Remanufactured Engine Caution For 1.9L DOHC Saturn Engines

Cylinder Head Bolt Caution On 2001-'02 GM 2.2L VIN F Engines

Revised Cylinder Head Torque On 2001-2002 3.1 & 3.4L Engines

Revised Upper Intake Manifold Gaskets For 1995-2004 GM 3.8L VIN K Engines

Figure 1 2001-'02 GM 2.2L Head bolt torque sequence.

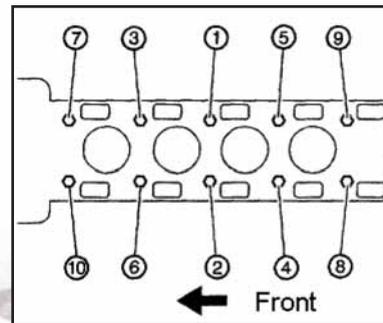
Saturn service manuals may have the incorrect torque listed for 2001-2002 GM 2.2L VIN F engines, says AERA's Technical Committee.

If the published torque is used, cylinder head bolts may break. Previously published head torque had an additional 185° added to the torque. The correct torque for this engine should be 22 ft.lbs. + 155°. Any time the cylinder head is taken off of this engine, cylinder head bolts must be replaced. Follow the torque sequence provided in **Figure 1**, above.

Figure 2 Apply around oil cooler on '97-2001 3.0L GM engines.

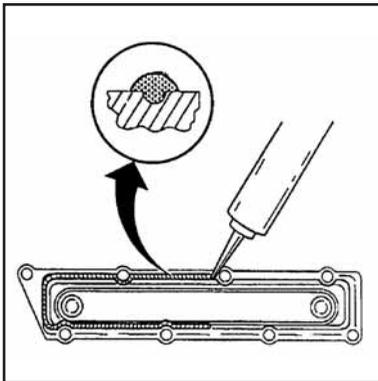
Customers/installers may complain of a low coolant light being on and/or engine overheating on 1997-2001 GM 3.0L VIN R engines, which was used in the Cadillac Catera. A leaking oil cooler cover due to an adhesion condition between the cover and the engine block may cause this condition.

Remove the oil cooler cover from the engine and the old sealant from the engine block and the oil cooler cover. Use only a plastic or metal scraper to remove the old sealant residue. Clean both surfaces using a solvent that will not leave any residue on those surfaces.

Apply a .080" bead of sealant (p/n 2378521; Canada use p/n 88901148 or equivalent), in the groove around the engine oil cooler cover as shown in **Figure**

Install the engine oil cooler cover back to the engine block and torque to 22 ft.lbs.

Figure 5 Oil pick-up tube for GM 4.2L 2002-'03 and part of 2004 (first design).

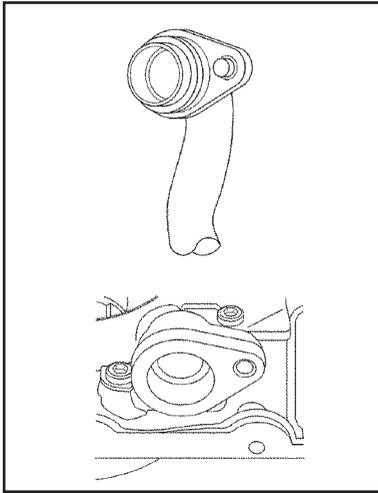
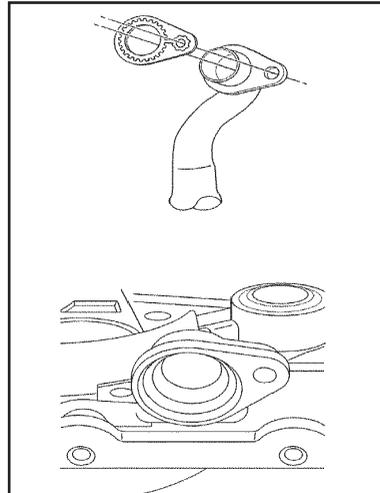
A revised engine oil pick-up tube and front cover components for 2002-2004 GM 4.2L VIN S engines went into production during the 2004 model year.

The first design (**Figure 5**, page 22) was used in production for 2002-2003 and part of 2004 model year and used an O-ring type seal between the pick-up tube and the front cover. The second design (**Figure 6**, page 22) was used during production model year 2004

and uses a face-type seal for the pick-up tube.

Any time the front cover or oil pick-up tube is serviced, be sure to identify which design is being serviced. The correct pick-up tube must be used with its corresponding front cover or an engine failure could result.

Any vehicle requiring a new front cover must be serviced with the second design front cover; therefore, the engine oil pick-up tube must be replaced at the same time.

Figure 7 Cylinder head torque sequence for 5.7L GM engine using 8 mm and 11 mm head bolts.

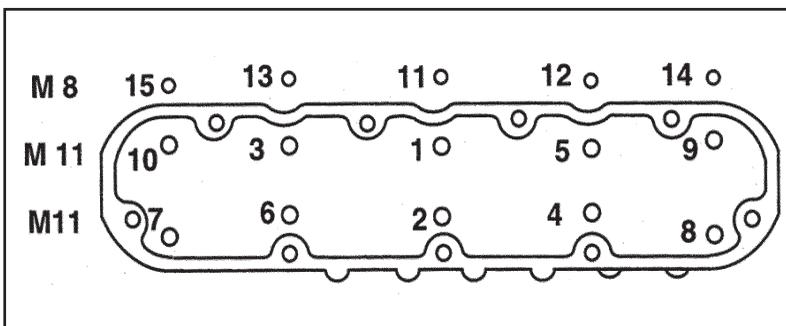
reuse the 8 mm head bolts and it is now recommended all cylinder head bolts should be replaced at the time of cylinder head installation. The new 11 mm bolts come with a pre-applied sealer and lubricant and no other sealant should be used on them.

The AERA Technical Committee offers the following information on a revised cylinder head installation procedure for 1997-2005 GM 5.7L VIN G and S engines.

This procedure (**Figure 7**, below) should be used any time the cylinder head is being installed and supersedes information found in earlier published service manuals.

1) Tighten new 11 mm bolts (1-10) in sequence to 22 ft.lbs. (30 Nm).

2) Rotate those bolts (1-10) in sequence an additional 90° turn using a torque angle meter.

3) Rotate only bolts 1-8 in sequence an additional 90° turn using a torque angle meter.

4) Rotate remaining 11 mm bolts 9 and 10 in sequence an additional 50° turn using a torque angle meter.

5) Apply a .200" (5 mm) bead of locking compound (GM p/n 12345382 or equivalent) to the new 8 mm bolt threads, and tighten bolts (11-15) in sequence to 22 ft.lbs. (30 Nm).

Do not re-use either the 8mm or 11mm head bolts. **EB**
